To: Planning Committee *To Planning - Apr 17, 2007*  
 From: Jean Lamontagne Date: March 30, 2007  
 Director of Development RZ 04-287969  
 Re: Application by Matthew Cheng Architect for Rezoning at 8411 and 8391 File: 12-8060-20-8234  
 Williams Road from Single-Family Housing District, Subdivision Area E (R1/E)  
 to Townhouse District (R2 - 0.7)

That Bylaw No. 8234, for the rezoning of 8411 and 8391 Williams Road from "Single-Family Housing District, Subdivision Area E (R1/E)" to "Townhouse District (R2 - 0.7)", be introduced and given first reading.

**Project: Proposed Townhouse Project  
8391 and 8411 Williams Road Richmond**  
**Re: Response to City Review of Arborists Report**

**TREE RETENTION PLAN**

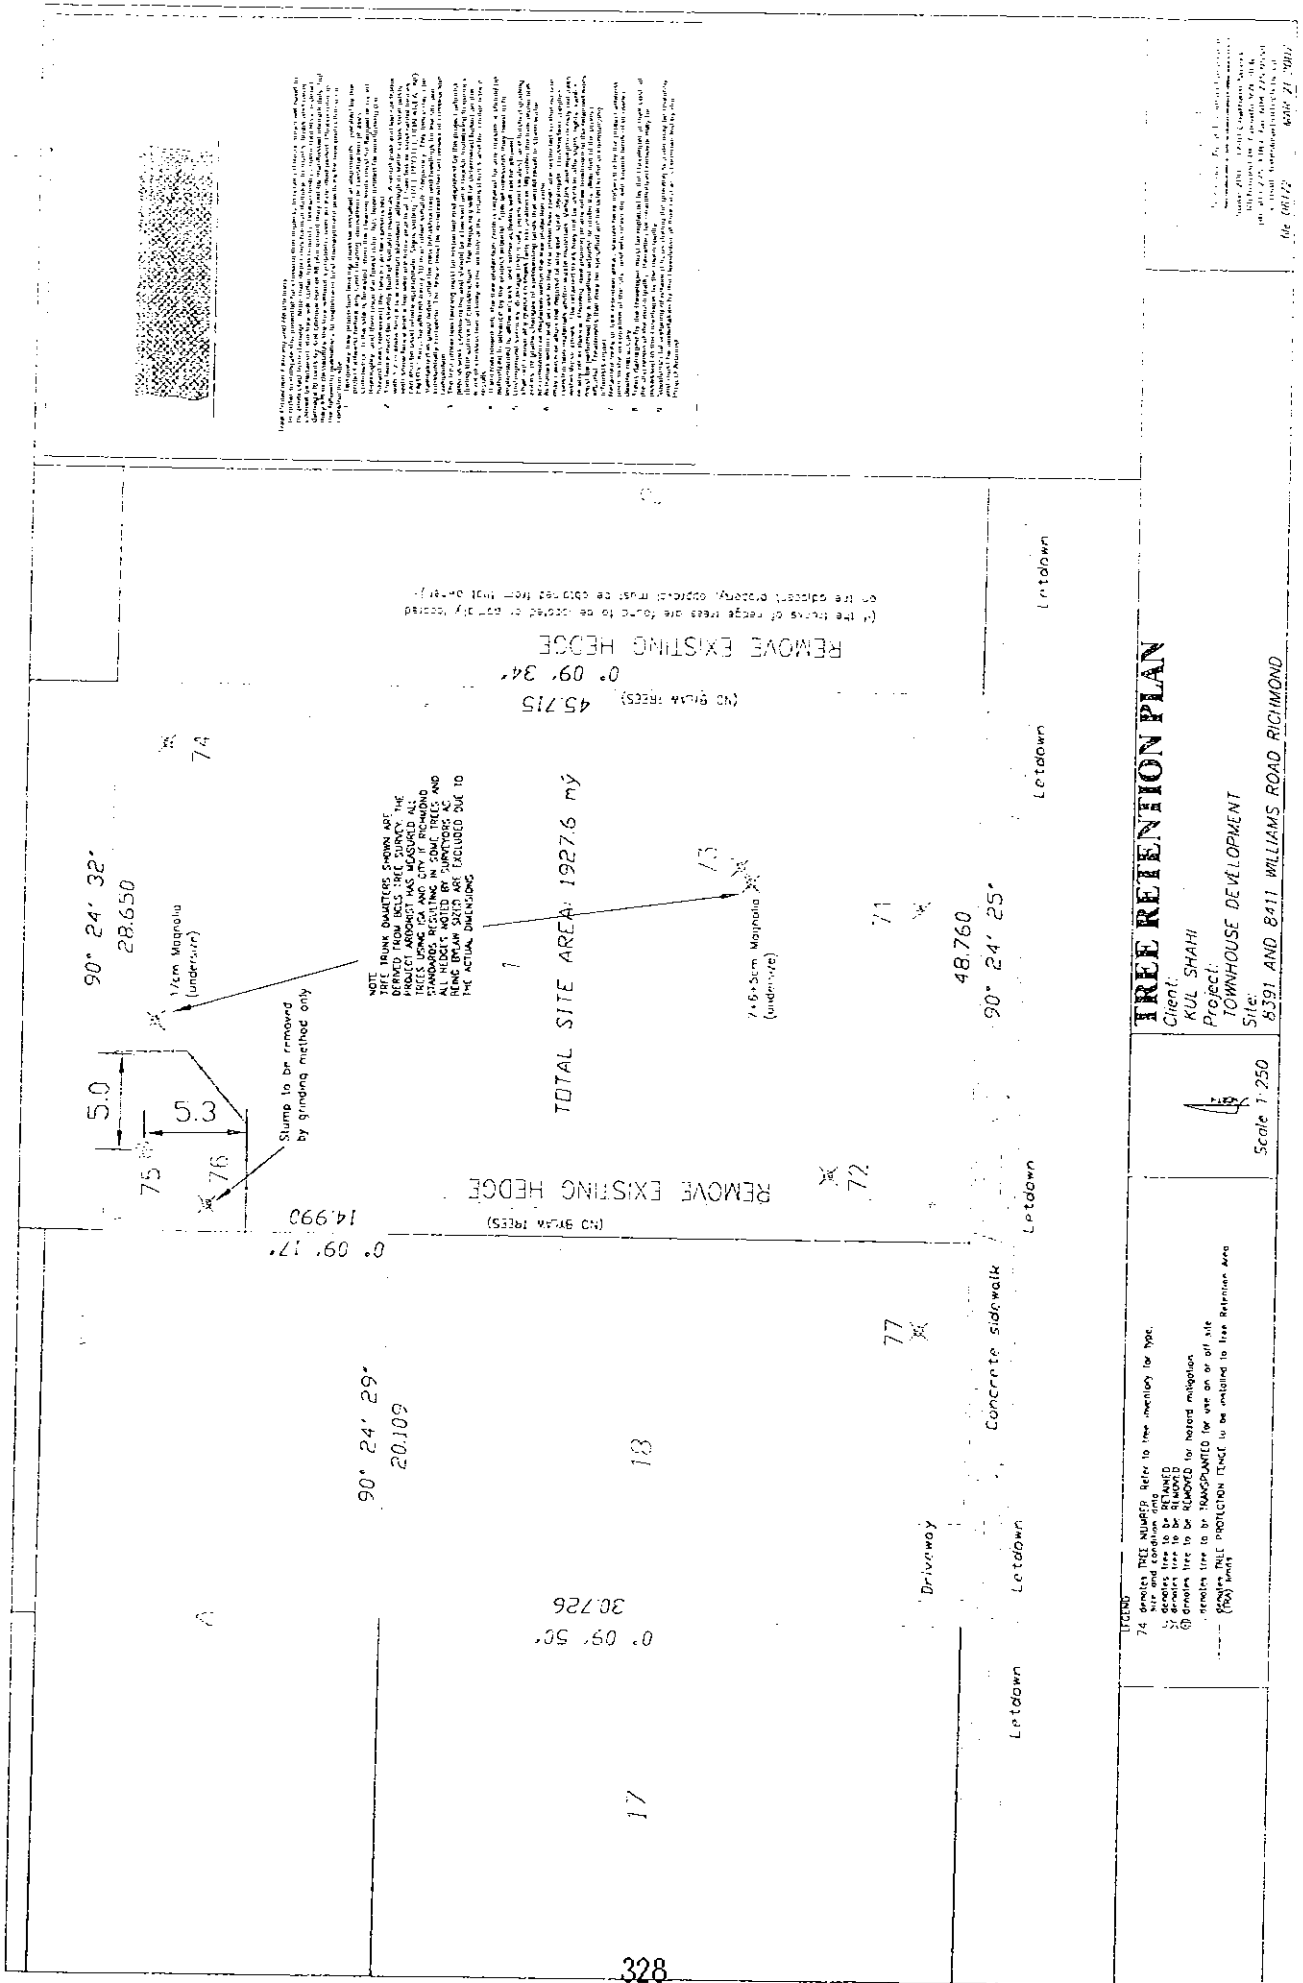
I have reviewed the information provided in the February letter from the city with regards to our submission of the tree retention report at the above referenced site. The Tree Retention Plan has been revised to reflect the comments from that document. Following are my comments.

- The hedge on the west side is now specified for removal. Indeed, this hedge is on poor condition. A note indicating the need for adjacent owners' approval if the trunks are located on the adjacent property. Based on the survey, the trunks of the hedge trees appear to be wholly located on the subject site, however the property line should be staked accurately before proceeding.

- Two undersized trees were marked on the tree survey with the incorrect trunk diameters. We had measured them and identified the species in our previous site visits, and recently added them to the plan as requested.

- The tree #75 that is proposed to be retained has a dripline radius of 5.0m. The tree protection fence is aligned to coincide with the dripline, meeting the city requirements. I have added dimensions to the plan for clarity.

- The stump for tree # 76 must be removed by low impact method. In order to protect the roots of the adjacent retained tree, I have specified that stump grinder should be used, as noted on the revised plan

- Only 7 bylaw sized trees are found on this site.
